Additional SAS-1.1 Expander Issues

September 28, 2005

Revised 10/28/05 after discussions with Tim Hoglund

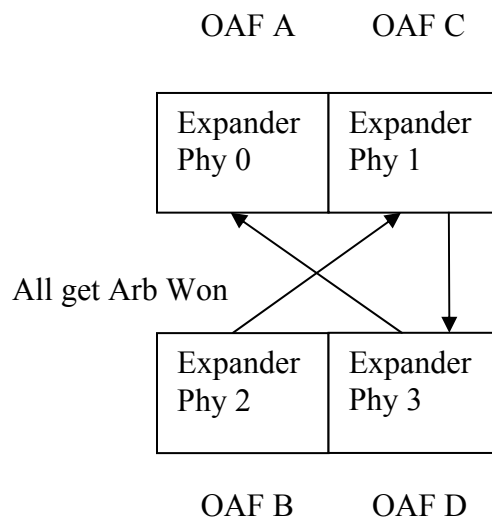
An additional qualification is necessary for an expander link to receive an Arb Won message from the expander function. Consider the following scenario.

Expander Phys 0, 1, 2, and 3 receive open address frames (OAF) A, C, B, and D respectively, where by arbitration rules $D > C > B > A$. Oaf A received on expander phy 0 requests a connection to expander phy 2, Oaf C received on expander phy 1 requests a connection to expander phy 3. OAF B is destined for expander phy 1 and OAF D is destined for expander phy 0.

Assuming there are sufficient routing resources and the connection rates are valid this scenario proves to be problematic. The expander function receives four request path messages from the respective expander phys. The value of phy status during this phase of the request path is such that Condition a) is satisfied for all ports. Condition b) is satisfied based on the assumption that the expander is designed accordingly. Condition c) rules out expander phy 0 to receive an Arb Won message since $OAF D > A$. Condition d) does not create any further restrictions since each OAF is destined to a unique expander phy.

Thus, since all conditions are met, an Arb Won message is issued to expander phy 3 with OAF D, expander phy 2 with OAF B, and expander phy 1 with OAF C. There are two error cases that need to be considered:

- 1) Expander phy 1 should not receive an Arb Won as it will cause a collision in the connection between expander phy 0 and 3
- 2) Expander phy 2 should not receive an Arb Won since OAF B sent to an end device attached to expander phy 1 will be ignored due to $C > B$. Further, expander phy 1 may have issued AIP due to receiving OAF C, which in turn could result in a hung connection attempt (i.e. an Open Timeout would not occur).

A recommendation to solve this problem is to add the following clause to the Arb Won qualification.

- e) the connection request of this expander phy is higher priority than an outstanding connection request of the destination expander phy.
